ADDENDUM NO. 3

PROJECT NAME: NE Soccer & Tennis Complex-General Construction
UNL PROJECT NUMBER: C909P101/ 10186
BID INVITATION NUMBER: 2339-14-7200

CONSULTANT: RDG Planning & Design
ADDRESS: 301 Grand Avenue
Des Moines, IA 50309

DATE OF ISSUANCE: April 4, 2014
DATE OF BID OPENING: Tuesday, April 8, 2014
3:00 PM CT

POST FOOTING SCHEDULE

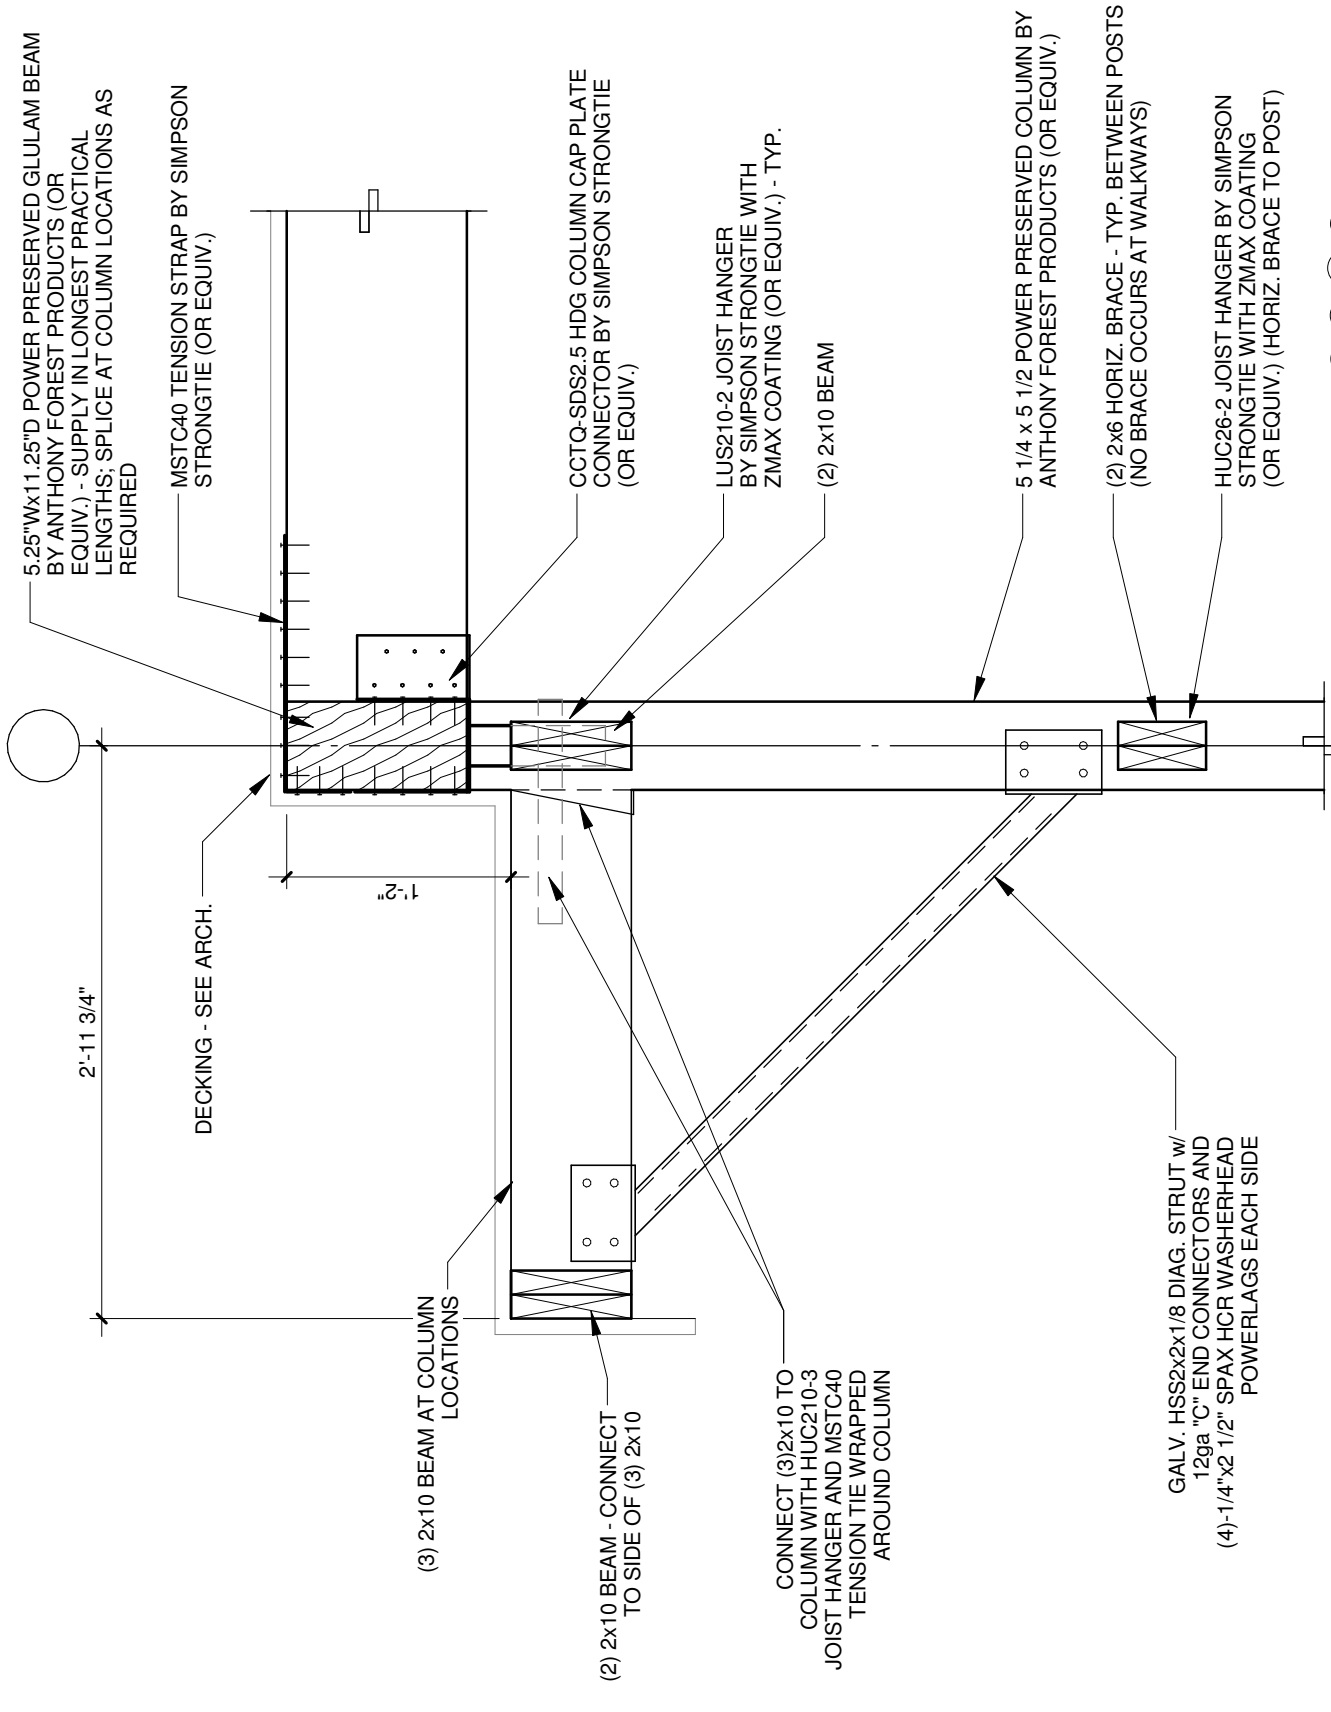
3GD-4 DRAWING S6.01:

A. Revises Post Footing Schedule per attached drawing AD3-S01.

WOOD CONNECTION DETAIL

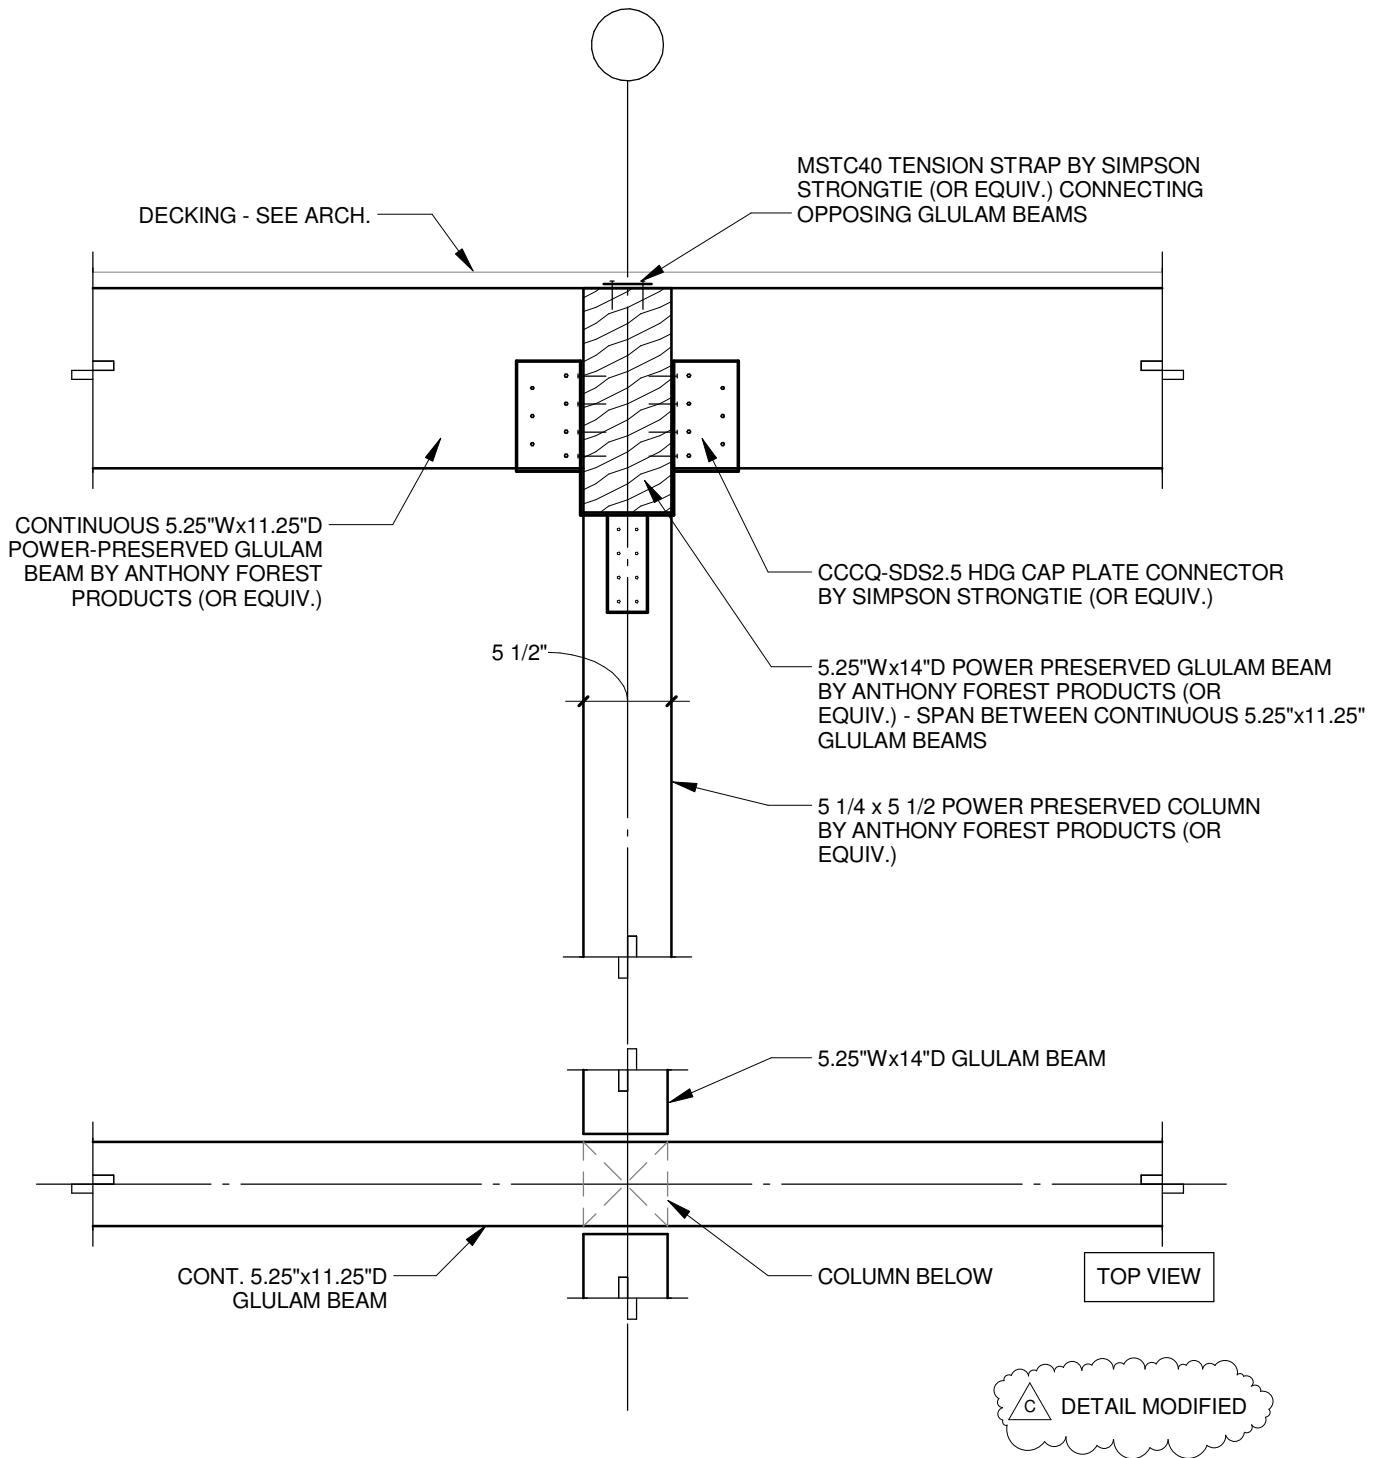
3GD-5 DRAWING S7.13

- A. Revises detail 1 per attached drawing AD3-S02.
- B. Revises detail 2 per attached drawing AD3-S03.
- C. Deletes detail 3.
